**Statement to Sound Transit Board of Directors on the  
Safety of the Seattle Link Light Rail Initial Segment  
by John Niles  
Coalition for Effective Transportation Alternatives  
April 10, 2003**

# Changes in Estimated Annual Collision Count Caused By Rainier Valley At-Grade Light Rail

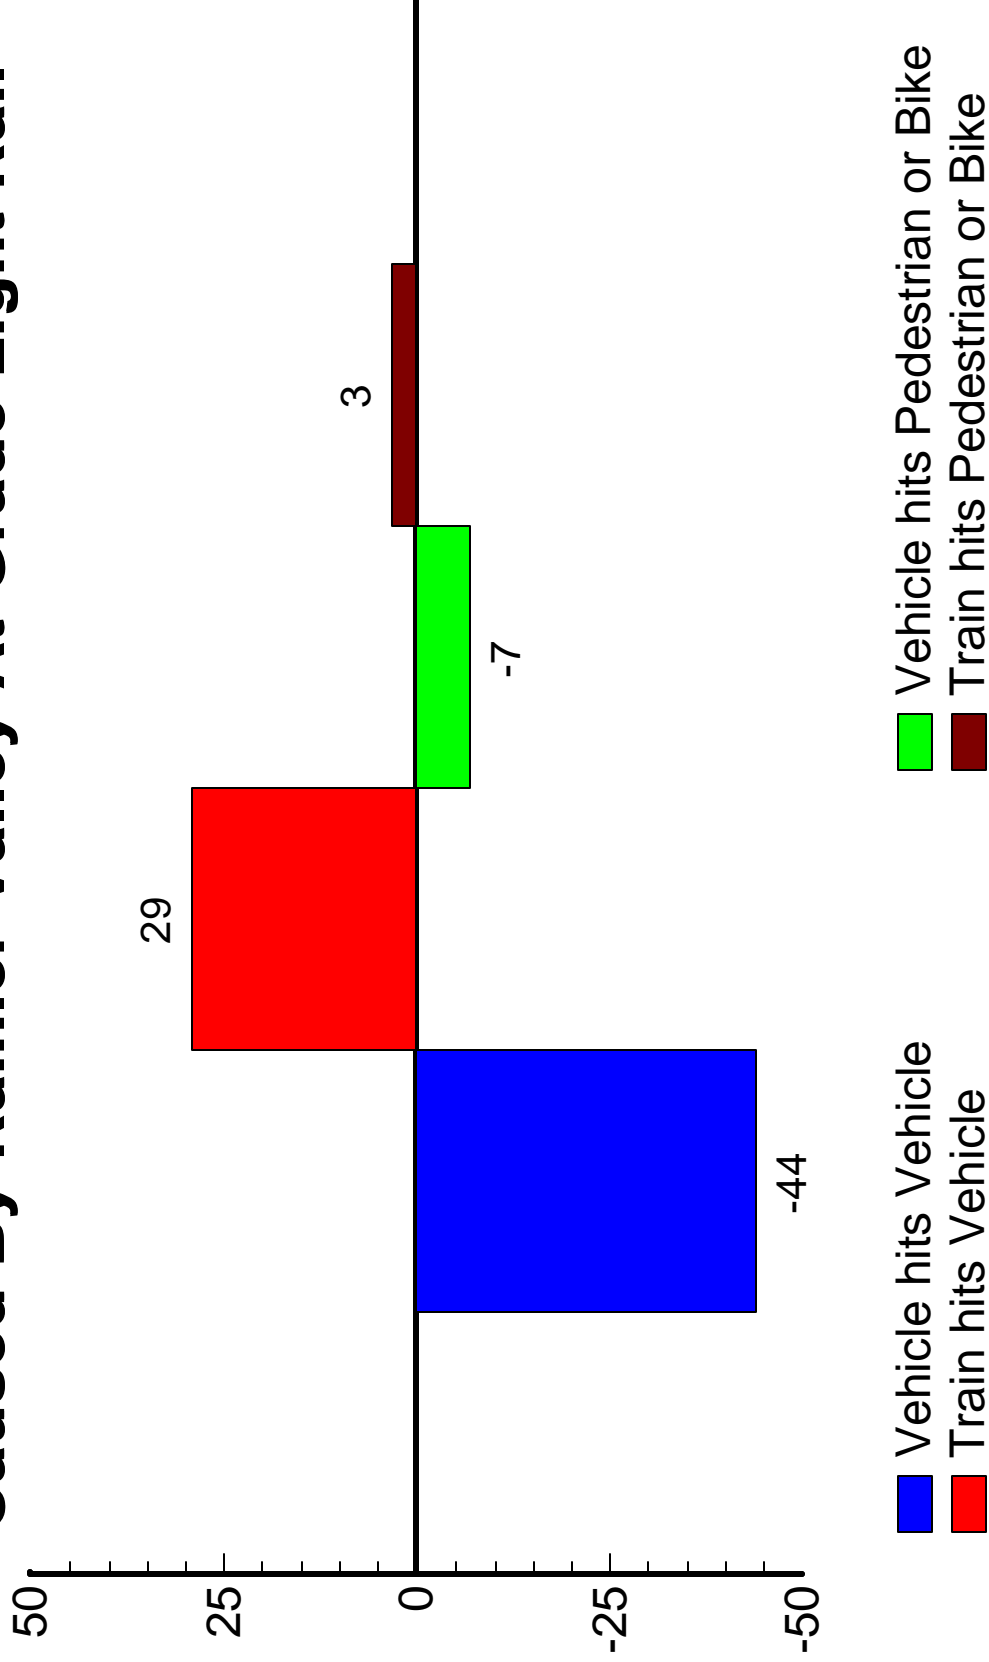
The magnitude of these different numbers are shown on the chart following. The two bars above the line represent the new light rail train-involved collisions expected annually as a result of the at-grade light rail design as calculated for the 1999 Final EIS. The two bars below the line represent the non-train-related collisions reduced as a result of redesigning MLK Jr. Way for light rail.

This logic of substituting one kind of accident for another kind is an invention of those who need to justify the present light rail design with its 18 ungated at-grade roadway crossings. The common-sense idea that getting hit by a train may be more serious than being hit by a car is not discussed. The fatality and serious injury rates from the various types of accidents traded-off are not discussed in the EIS. Furthermore, this kind of trade-off between accident types across modes is not covered in Federal Hazard Analysis Guidelines or Safety Certification Guidelines for fixed-guideway transit systems.
